SECTION 00911 - ADDENDUM 2

- A. Project Name: South Main Corridor Improvement Project (Phase II)
- B. Engineer: SK Design Group, Inc.
- C. Engineer's Project Number: 16-108.
- D. Date of Addendum: August 3, 2023

South Main Corridor Improvement Project (Phase II)

SE002

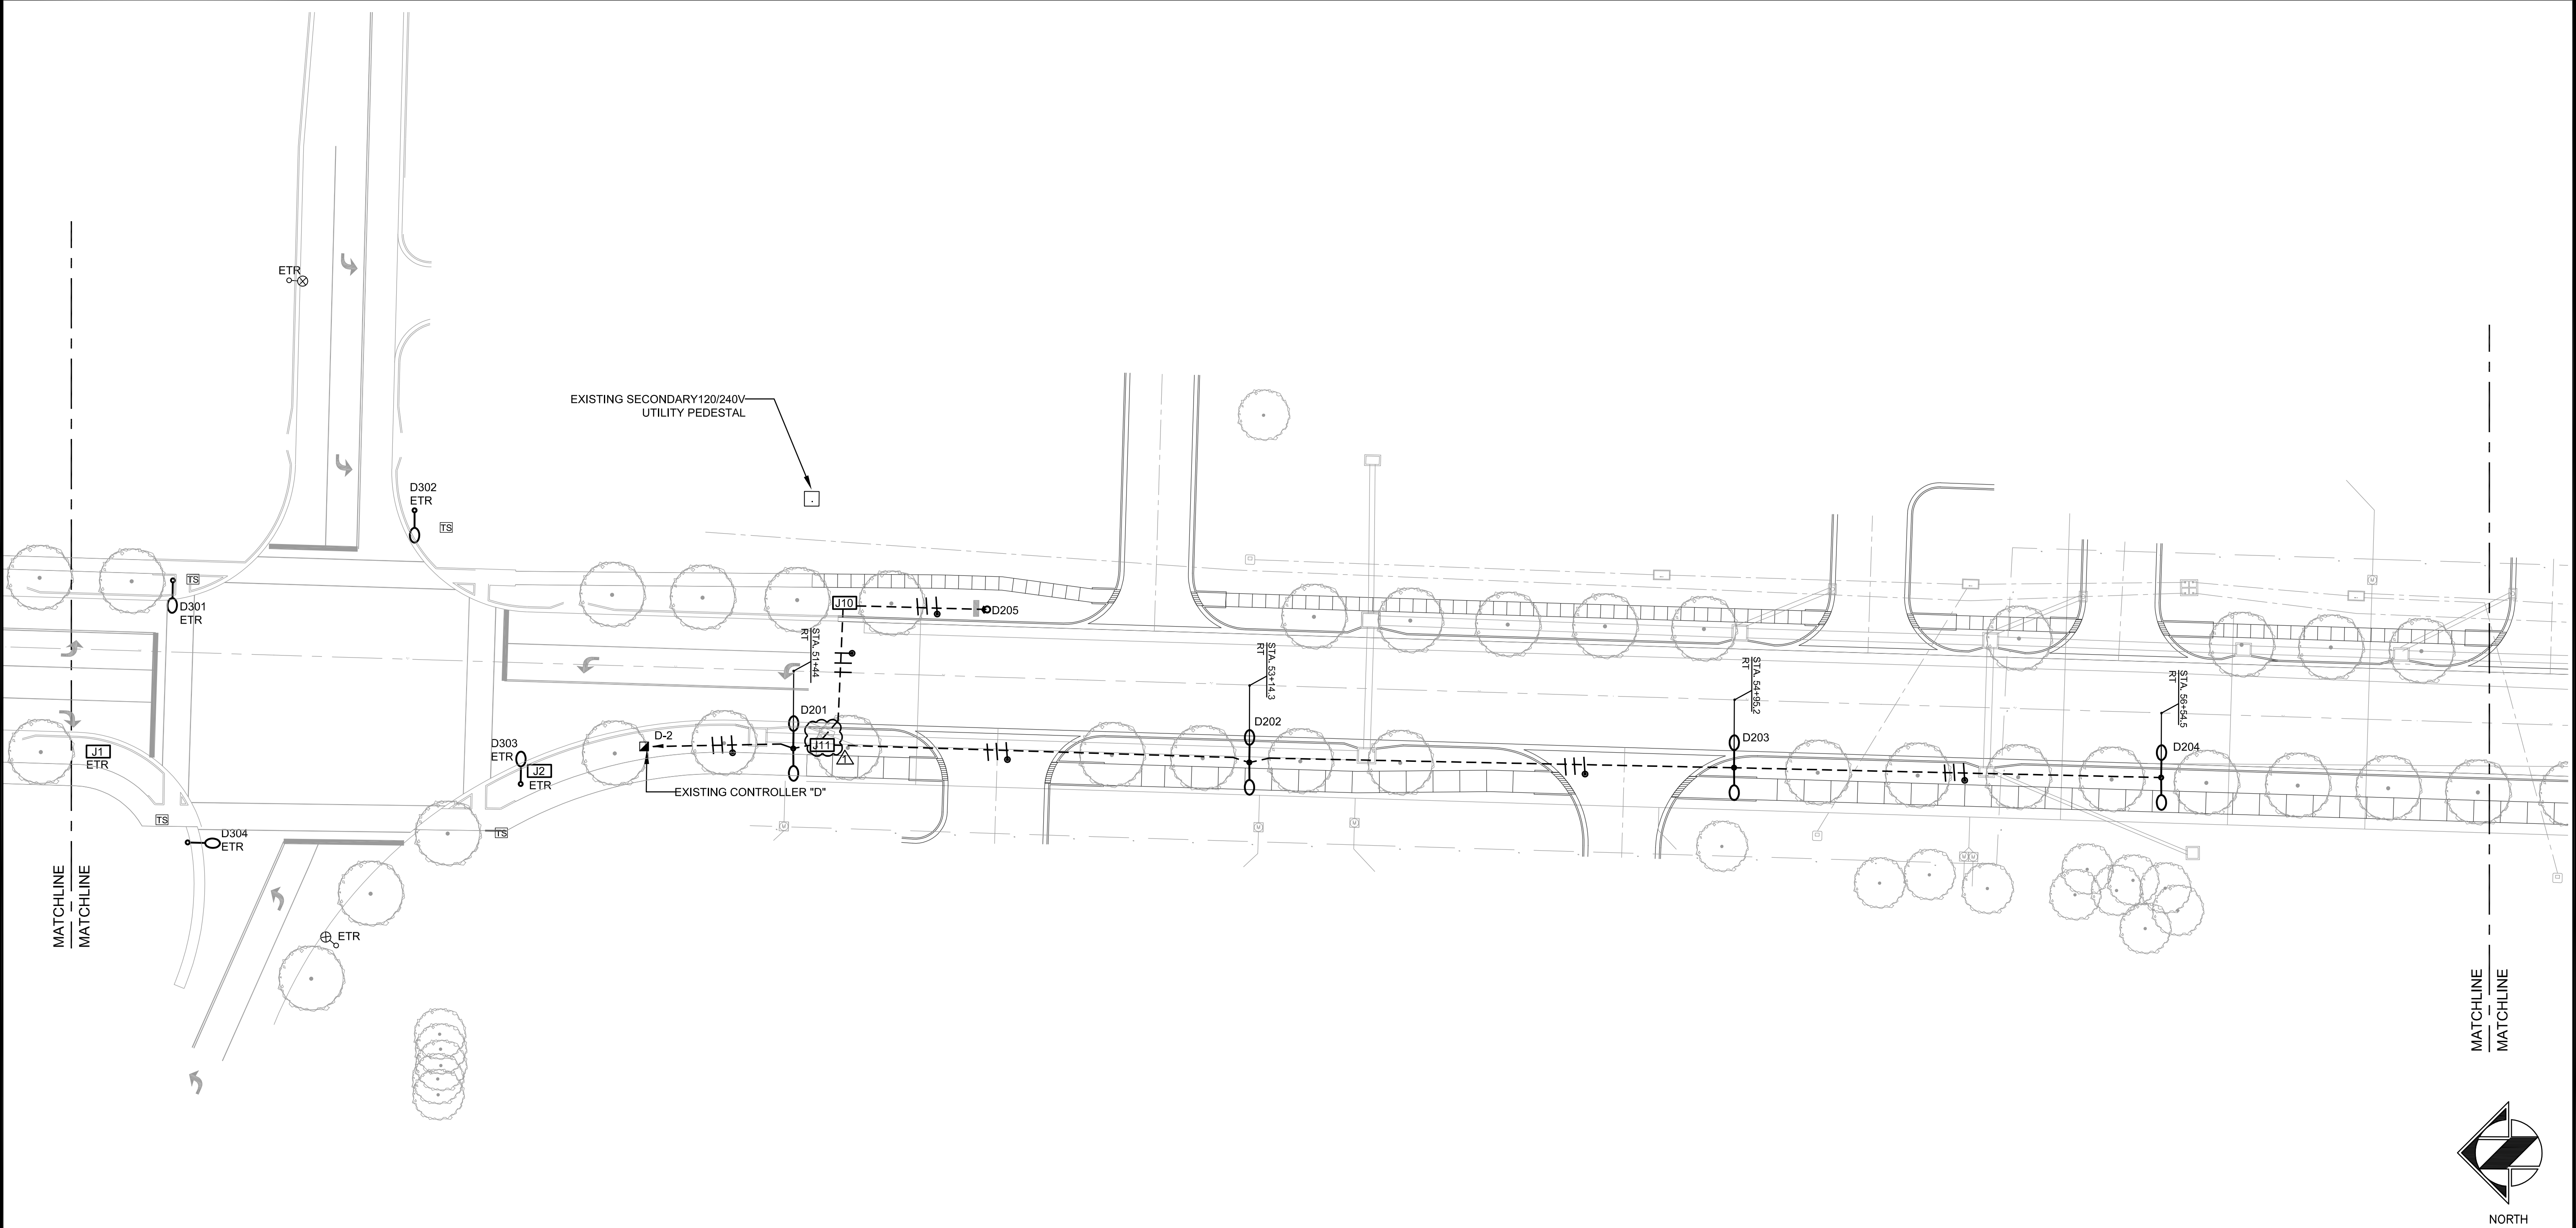
- A. Question: On drawing SE002 identifies controller F as a 4-circuit controller on the electrical improvement schedule, however on drawing SE 204 it indicates controller F to be a 2-circuit controller. Please clarify if controller F is to be a 2 circuit or 4 circuit controller.

- B. Question: On SE 204 the drawings show 2-2" conduits going from controller F to JB 8. On page SE002 the electrical improvement schedule indicates one conduit going from controller to JB8 and one conduit from Controller to F201. Please clarify the correct routing.

- F. Question: On drawing sheet SE002 electrical improvement schedule it indicates 84 feet on each pole for wire within the pole. This seems to be small quantities due to the pole being 30' with an 8' arm and a second light at 15' with a 4' arm. Can you verify the configuration and if the wire quantity is correct.

Response: Streetlighting is a lump sum bid item and will not be measured. Quantities shown on this sheet are approximate. Contractor is responsible for providing all materials necessary to install the improvements shown on the Streetlighting plans. See attached revised sheet SE002 which includes this note.

SE201

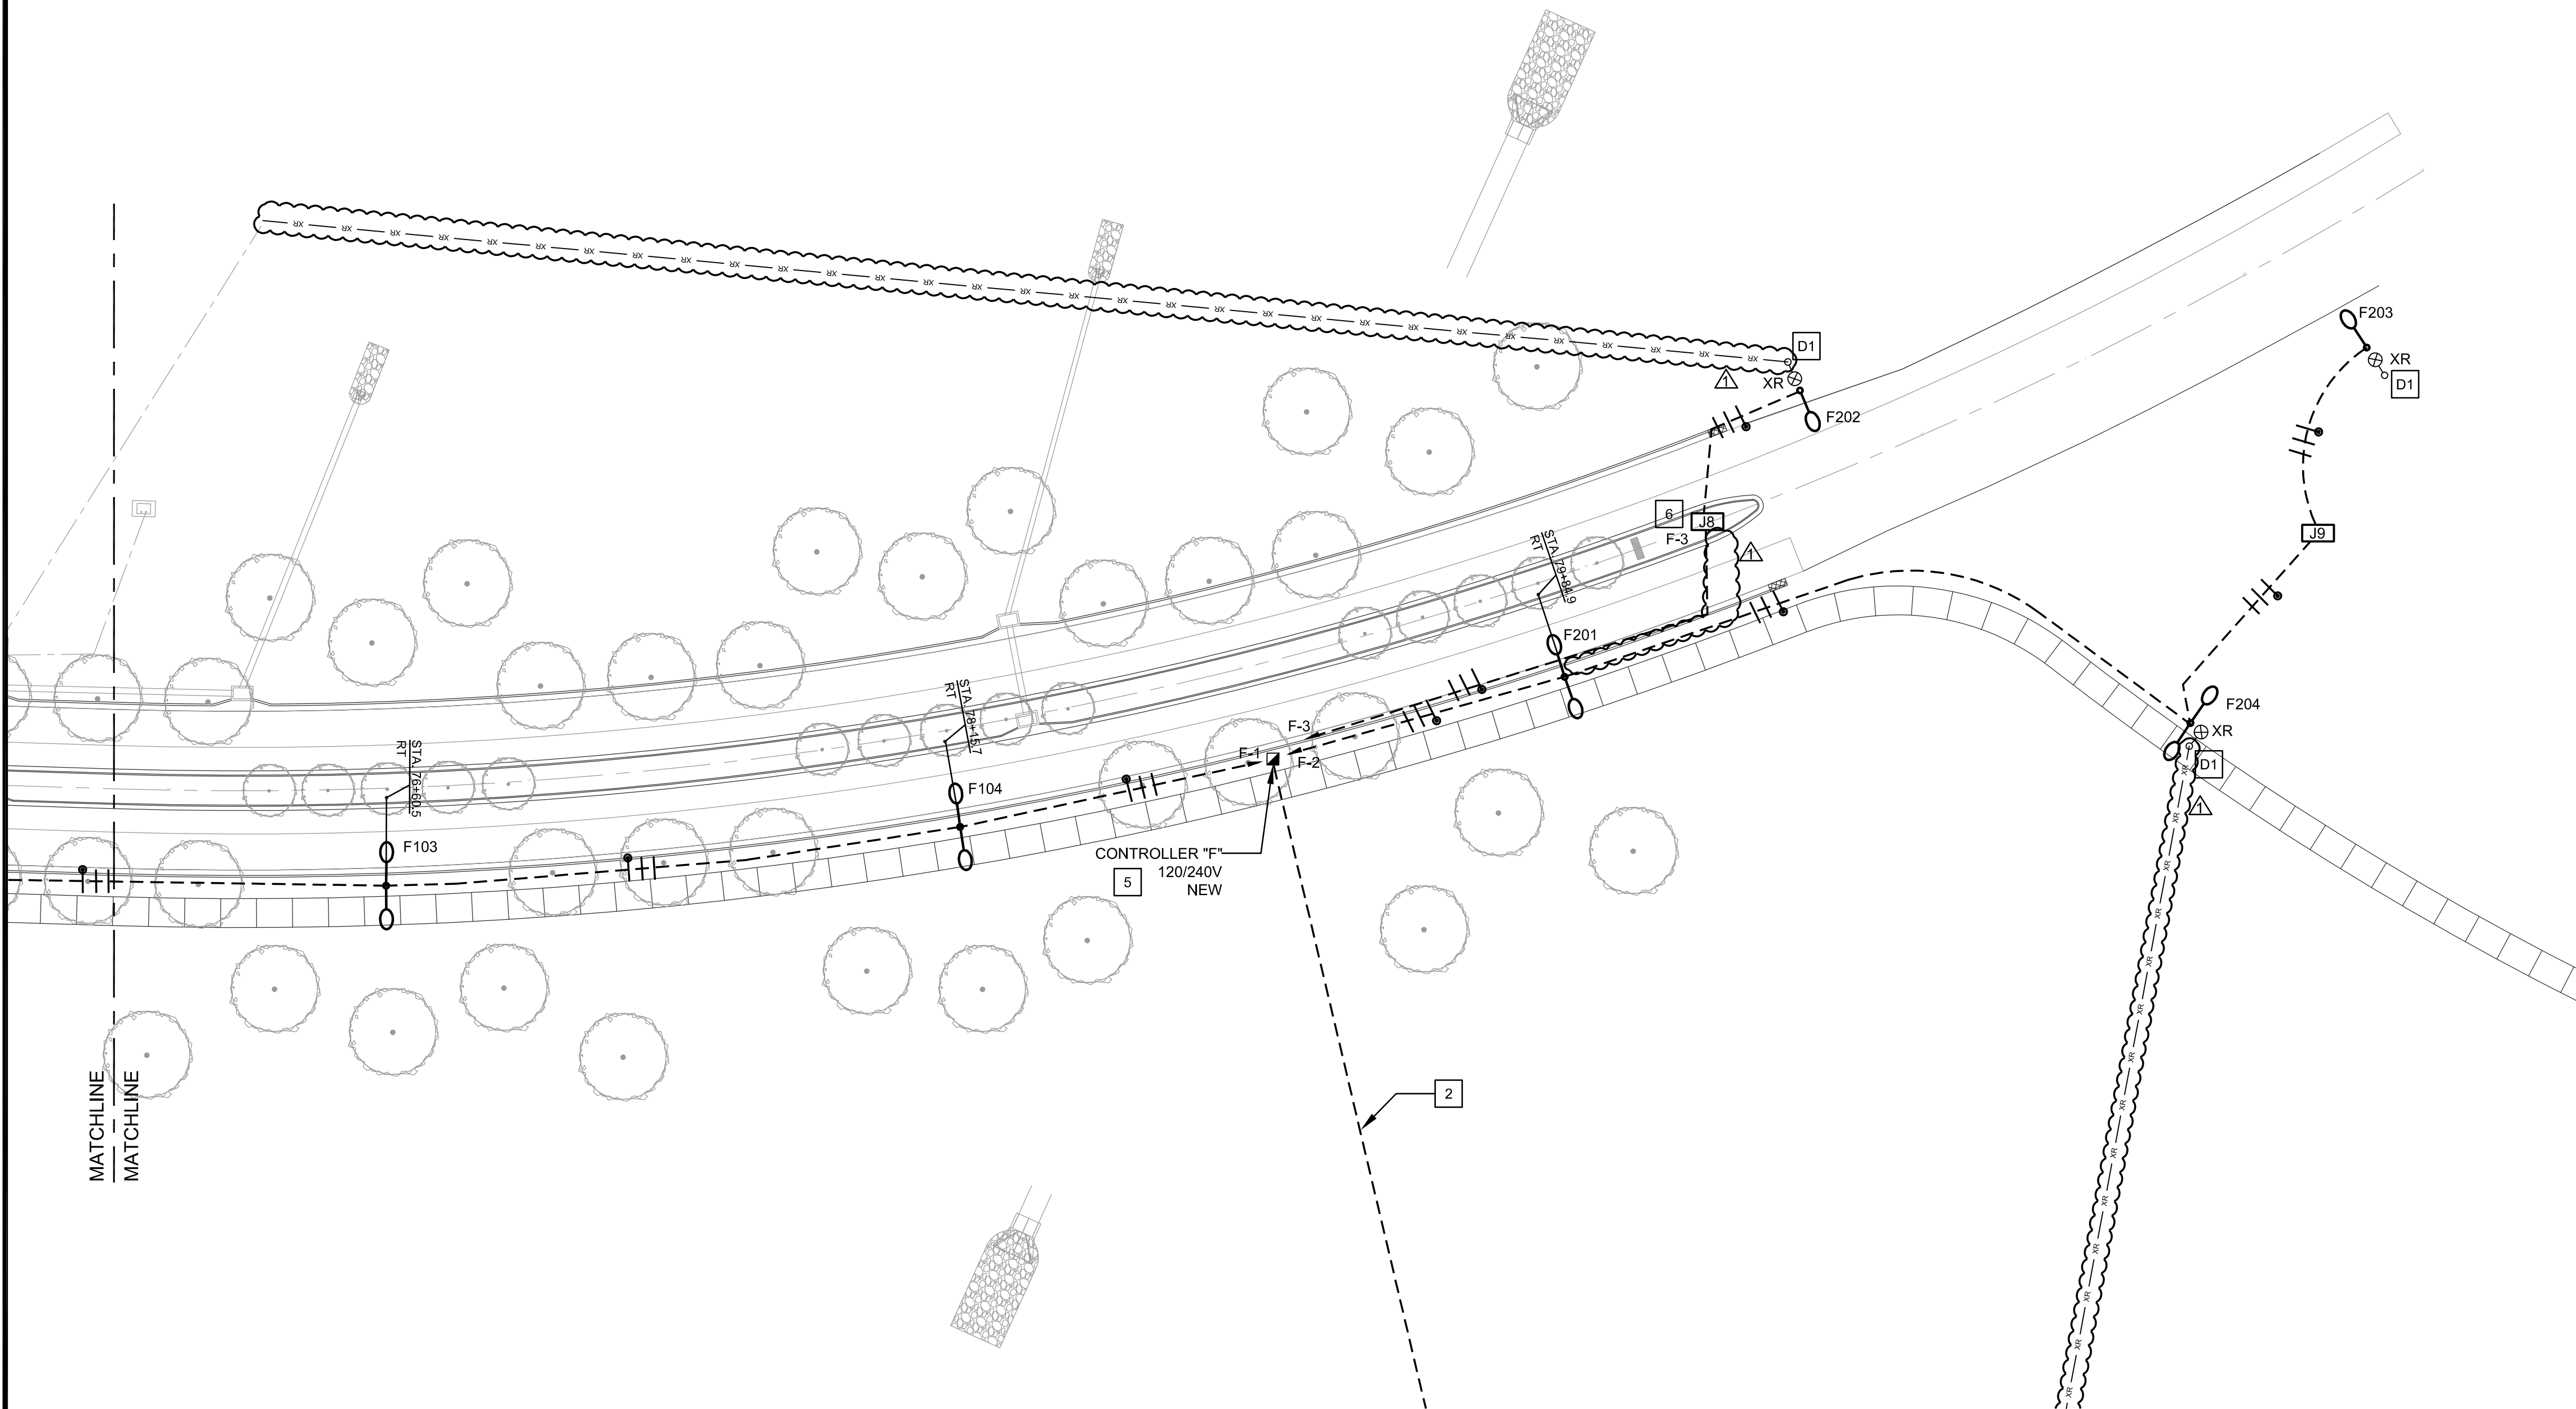
- C. Question: On Sheet SE205 at D201 indicates 3-2" conduits to be stubbed up in to the street light base. Due to the room in the screw in base and the cable retainer this is very difficult and from a maintenance stand point difficult to replace if there are issues. We would propose a junction box be installed in front of D201 and then one conduit ran into the base of the foundation.

Response: Note, Sheet SE205 label is revised to SE201 by this Addendum. The new SE201 (previously SE205) is revised to add a JB ahead of D201 to accept the conduits from JB10 and D202. A conduit is added from JB10 to D201. See attached revised Sheet SE205.
